**Met One Instruments**  
1600 Washington Blvd.  
Grants Pass, OR 97526  
Tel. 541 471 7111  
Fax 541 471 7116

***FAX***  
***TRANSMITTAL***

**To: Mr. Bhachu**  
**U.S. Nuclear Regulatory Commission**  
**Date: 2/7/02 No. pages 13**  
**Fax 301 415 5369**

This fax and the attachments within address the issues your office has regarding the Met One Instruments registration request for the model E-BAM beta attenuation mass monitor.

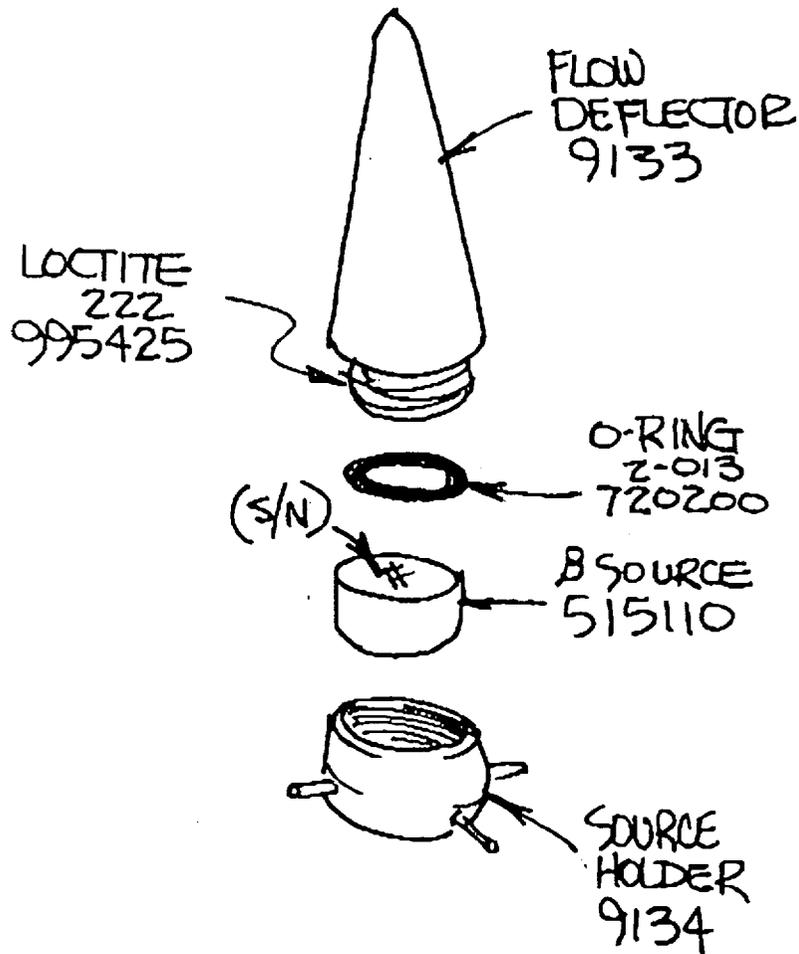
The label dimensions have been added to the drawing in Appendix D of the application.

TOLERANCES (EXCEPT AS NOTED)			MET ONE INSTRUMENTS, INC. GRANTS PASS, OREGON	
DECIMAL		E-BAM	O-RING, 2-013	
FRACTIONAL		MATERIAL NOTED	DRAWN BY LDW	DATE 4 FEB '02
ANGULAR		FINISH CLEAN & DRY	DATE 5 Feb '02	SCALE NONE
			DATE 5 Feb '02	DRAWING NUMBER 720200
				REV. A

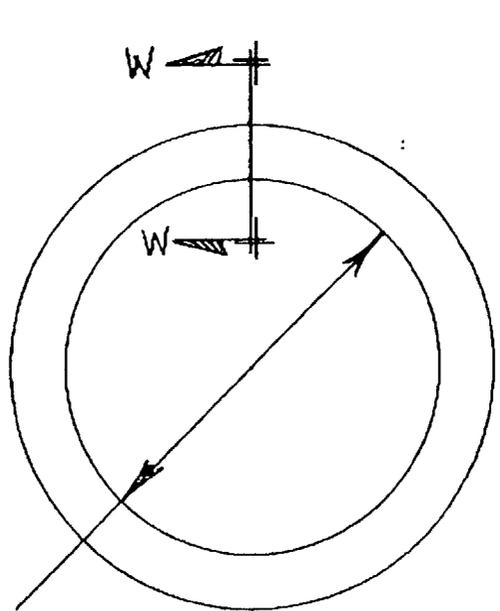
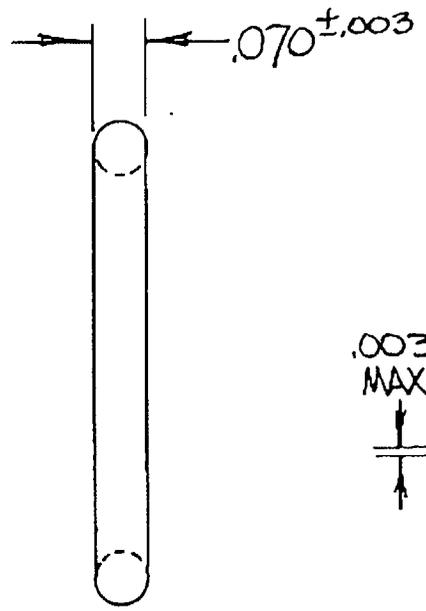
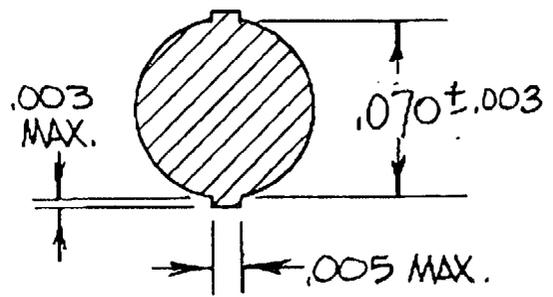
The drawing for the O-Ring, Part# 720202 has been added to the Appendix A (Detailed Drawings) of the application. The O-Ring drawing calls out the material and characteristics of the O-Ring. Furthermore, page 2 of the Assembly procedure in Appendix C of the application has been modified to include step 3 and 4. These steps prevents over tightening and hold the source securely in place.

- 1.) MATERIAL - NITRILE (BUNA N)  
DUROMETER 70 ± 5 SHORE A
- 2.) MFR/PN - PARKER 2-013-N674-70  
(SIZE PER AS568A-013)

Issue # 2

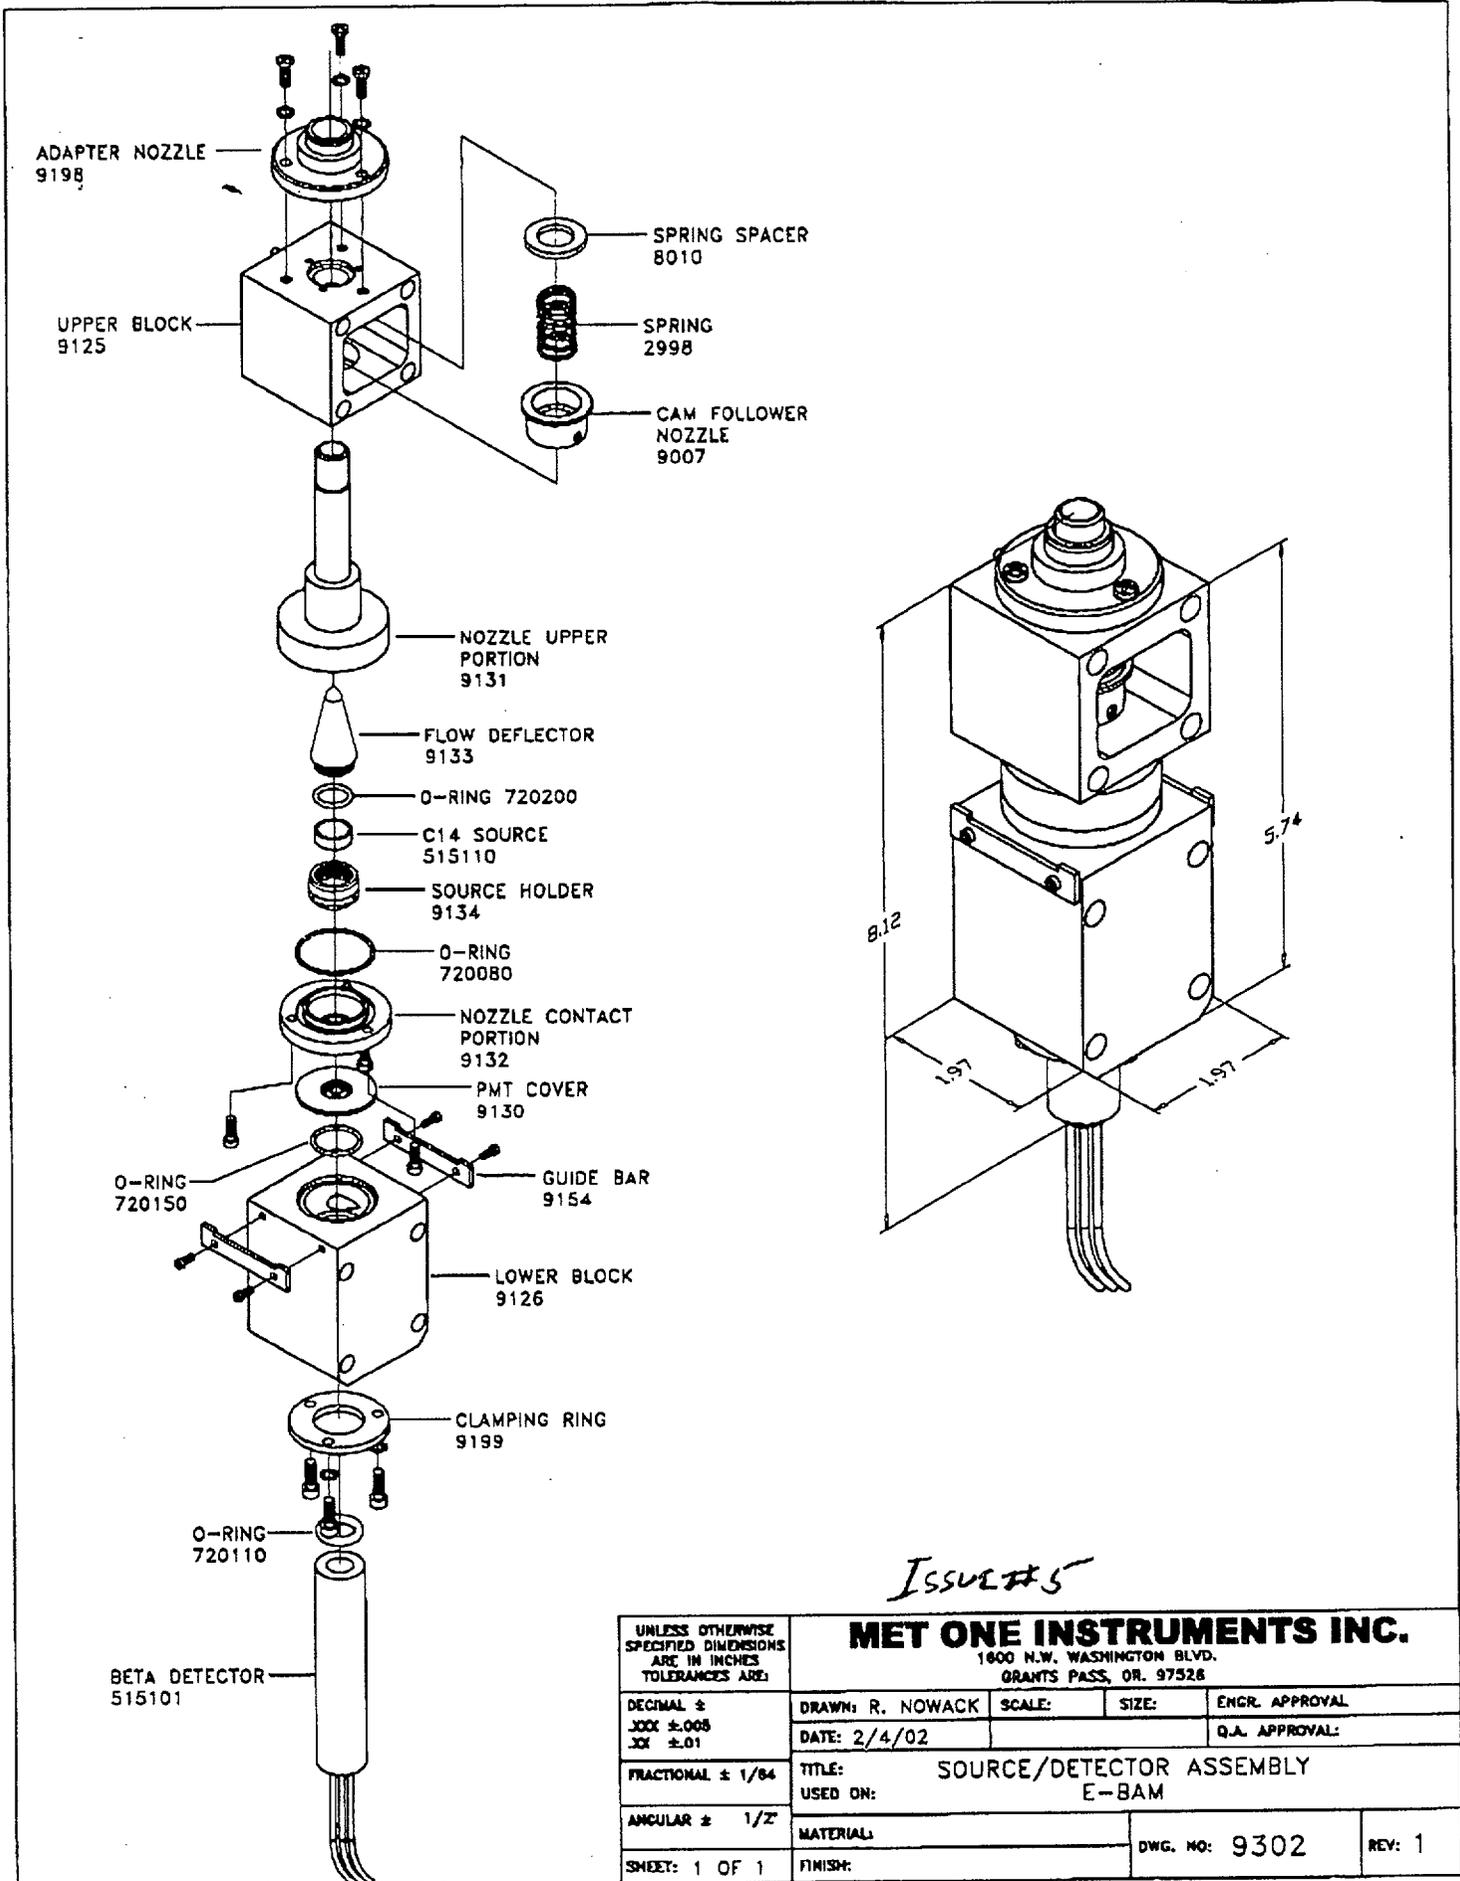
An assembly drawing of the important containment parts has been added to Appendix A (Detailed Drawings) of the application. Overall dimensions are included.

*Issue #5*
